BLACKLICK CREEK WATERSHED ASSOCIATION  
RICHARDS AMD PASSIVE TREATMENT PROJECT  
PHASE II  
CHERRYHILL TWP. INDIANA CO.

**BLACKLICK CREEK WATERSHED ASSOC., INC.**

Richards 2A and 2B – Clymer, PA Route 403

**System Modifications**

VERTICAL FLOW REACTOR (V.F.R.)  
SYSTEM DETAIL-TYPICAL

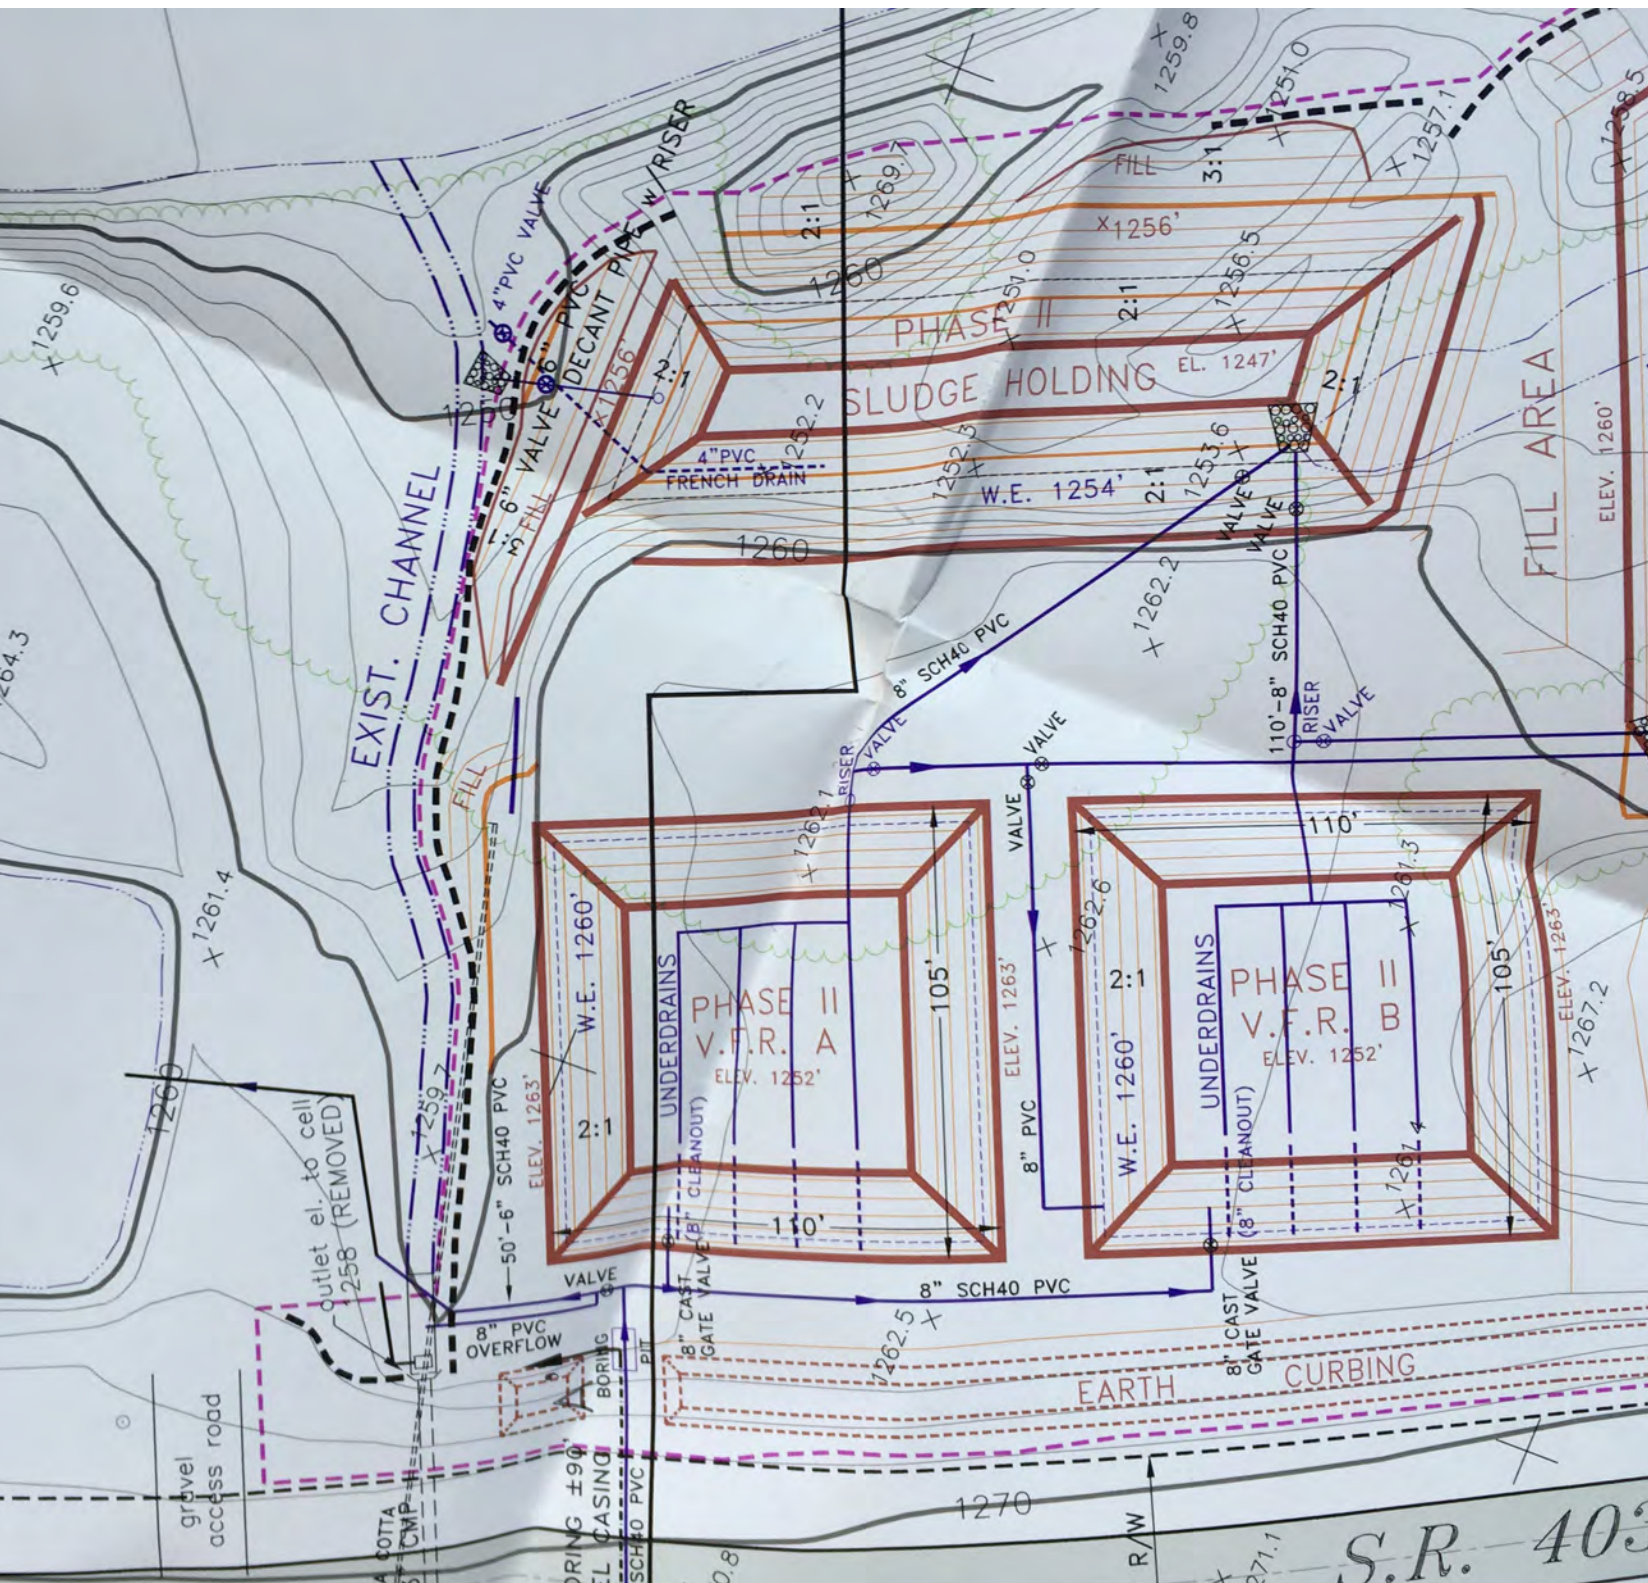
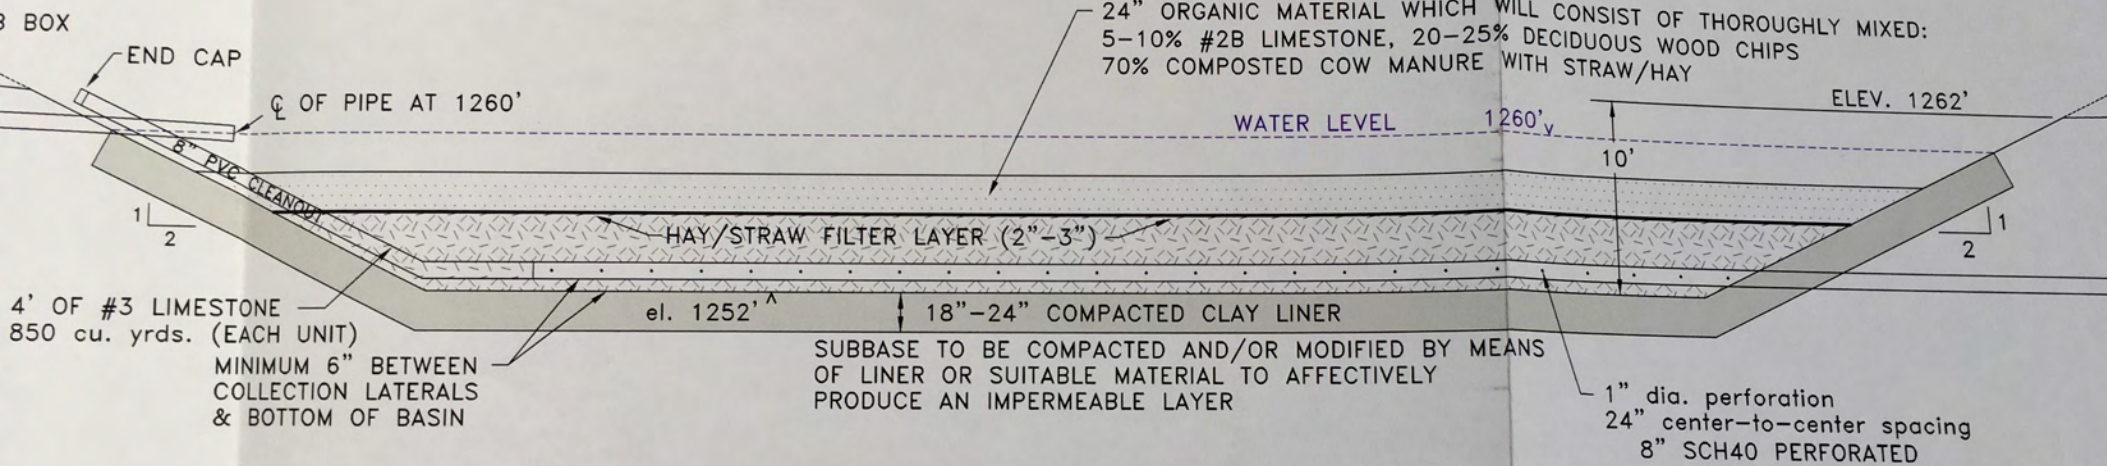
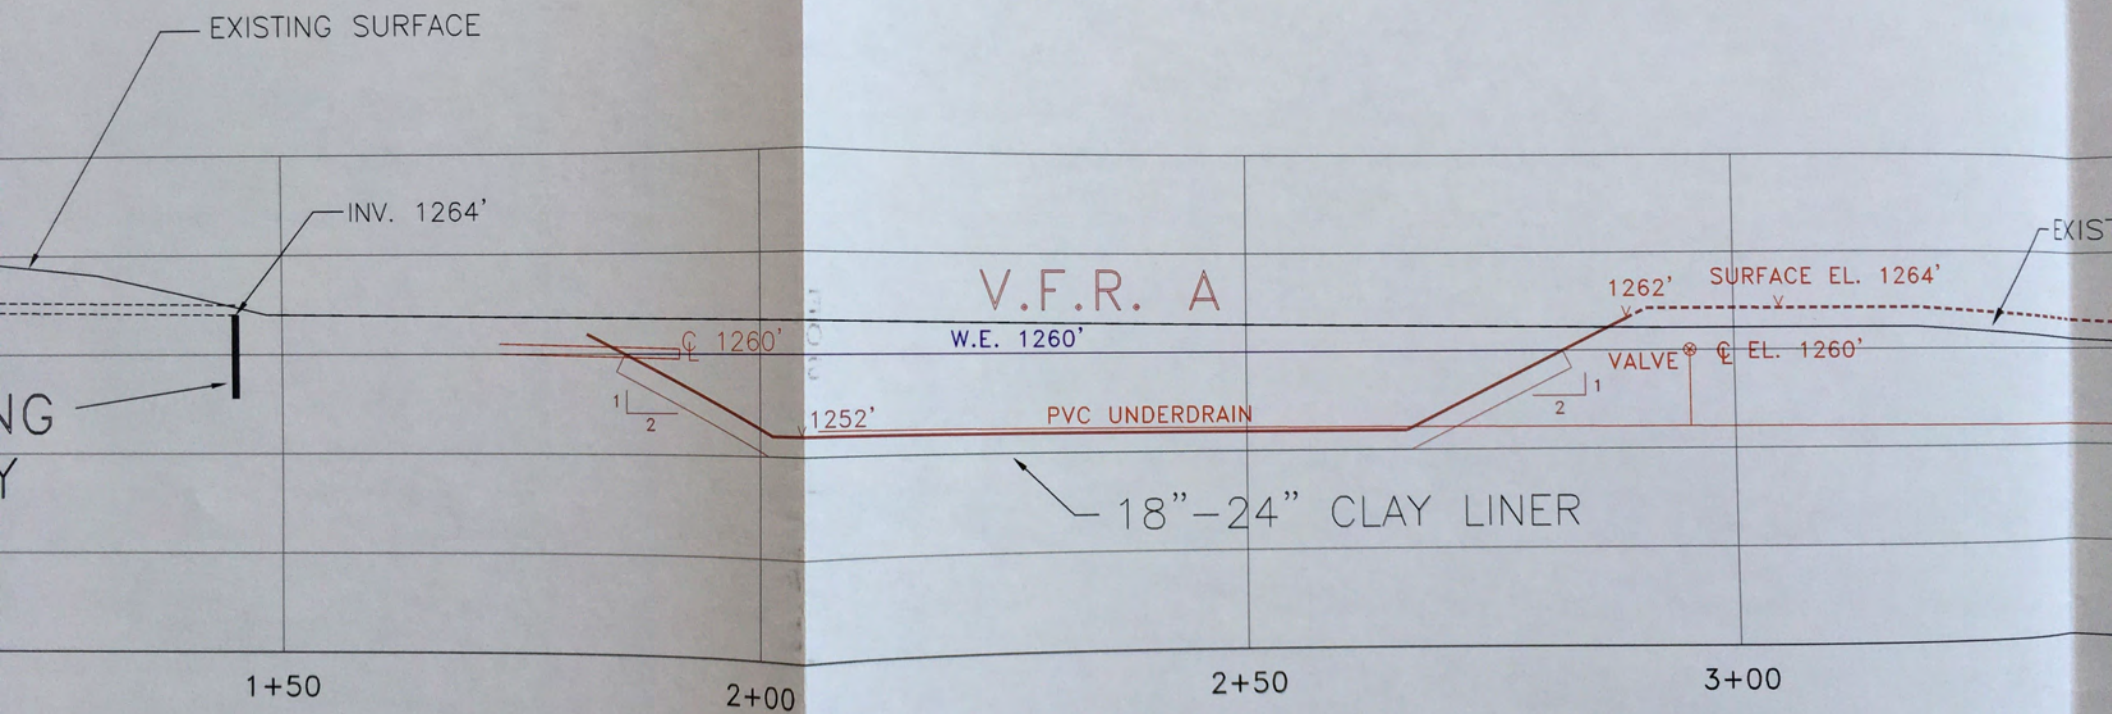
1. Remove/remix VFR/SRB organic mixtures, clean green vegetation and add hardwood slats/chips (20 tons to each VFR).
2. Replace well mixed VFR/SRB mixtures over base stone in place using "paint out" procedure (NO COMPACTION OF MIX).
3. Add valve box vertical extensions to valves A1, A2, A3, B1, B2, B3.
4. Raise elevations of all VFR pond berms by 2 feet with clay soils, keyed into present berms with minimum 8 foot wide tops for road access.  
(approx 750 cubic yards)
